## TECHNICAL BULLETIN 002 June 2013

Piston screws p.n. 1800.00, 1800.01, 1800.10, 1800.11, 1802.23 and 1802.27

Piston nuts p.n. 0302.05, 0302.11 and 0302.19

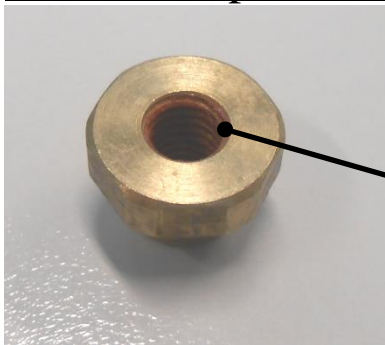
Locking  
adhesive

Locking  
adhesive

The screws and nuts have been changed to avoid unscrewing under severe vibrations. The locking adhesive is dry-to-touch and it is activated during assembly and cures to form a tough polymer that eliminates movement between the threads and provides a total seal. The new screws and nuts are interchangeable with the old ones and all part numbers did not change.

### Viti fissaggio pistone codici 1800.00, 1800.01, 1800.10, 1800.11, 1802.23 and 1802.27

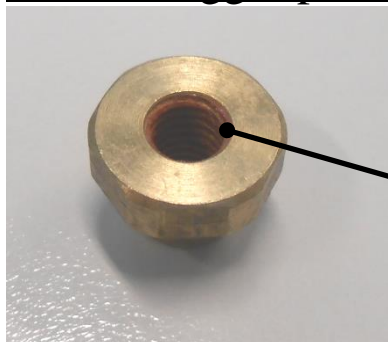
Adesivo  
bloccante  
preapplicato

Adesivo  
bloccante  
preapplicato

Le viti ed i dadi arresto pistone sono stati modificati per evitare svitamenti in presenza di forti vibrazioni.

L'adesivo bloccante preapplicato è formato da microcapsule che si frantumano in fase di assemblaggio rilasciando un attivatore che avvia il processo di polimerizzazione. Il prodotto polimerizzato si interpone tra le filettature riempiendo tutti gli interstizi bloccando e sigillando.

Le nuove viti ed i nuovi dadi sono intercambiabili e i codici non cambiano.
